Site Address: 7685 GREENHAVEN DR SAC
Parcel No: 031-0490-025

Nature of Work: TEAR OFF SHAKE AND REROOF W/LIGHTWEIGHT TILE 27 SQRS

September 9, 1999

Subject: Roof evaluation for 7685 Greenhaven Drive, Sacramento

PLAN VIEW OF ROOF RETROFIT
NTS

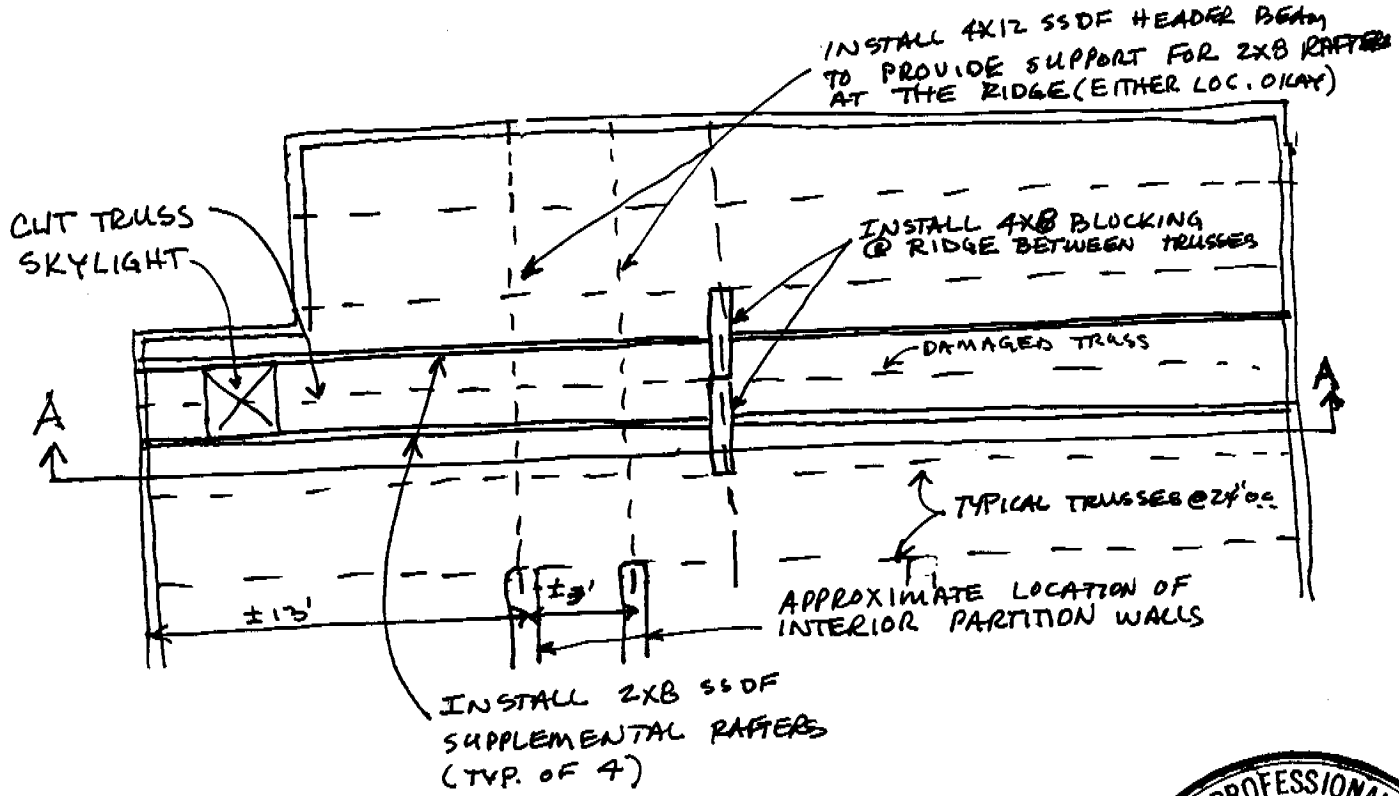
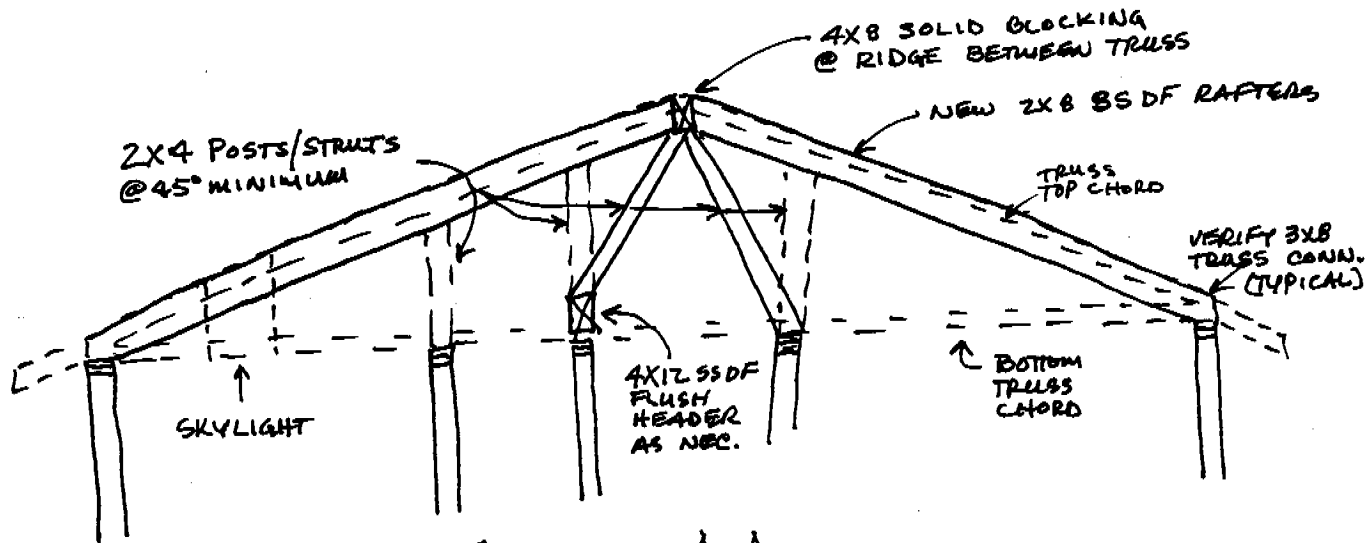
2. The Skylight in the Master bathroom ceiling was not installed properly. The Truss manufacturer provided an extra Truss to accommodate the Skylight, but the framing crew did not utilize it. The intended/proper installation would require installing a complete Truss on each side of the Skylight. Instead they "sistered" or spliced the extra Truss adjacent to the regularly spaced Truss adjacent to the Skylight, and cut the top and bottom chords of the regularly spaced Truss that conflicted with the Skylight. The altered Truss is not effective.

- ① — 1. Manufactured Roof Trusses: Field verify (after "tear-off") that connector plates joining the top and bottom Truss chords are at least 3"x 8".
 - ② — 2. Install a 4x12 SS DF Flush Beam(s) as necessary at the Ceiling over the Master Bath supported on the southerly exterior Bearing Wall and the interior Partition Wall located approximately 13', 16', and 23' from the rear exterior Bearing Wall. Install supports under each end of the 4x12 to prevent deflection contact with the bottom chords of the Trusses. Install 2-4x8 Blocks at the Ridge between the Trusses on each side of the cut Truss. Install 2x8 #1/btr DF Rafters on each side of the Skylight [Four (4) total] from front to rear. The existing framing will provide a sufficient Tie for these new Rafters. Provide lateral support for the 4x12 Headers to prevent rotation. *Field verify that roof bearing is to a bearing wall*

- ③ — Support the new 2x8 Rafters at or near the Ridge with 2x4 Posts/Struts at 45°, minimum, down to the 4x12 Flush Beam(s) and other interior Partition Walls running perpendicular to the Trusses with the intent of distributing the Roof load from the new Rafters as much as possible
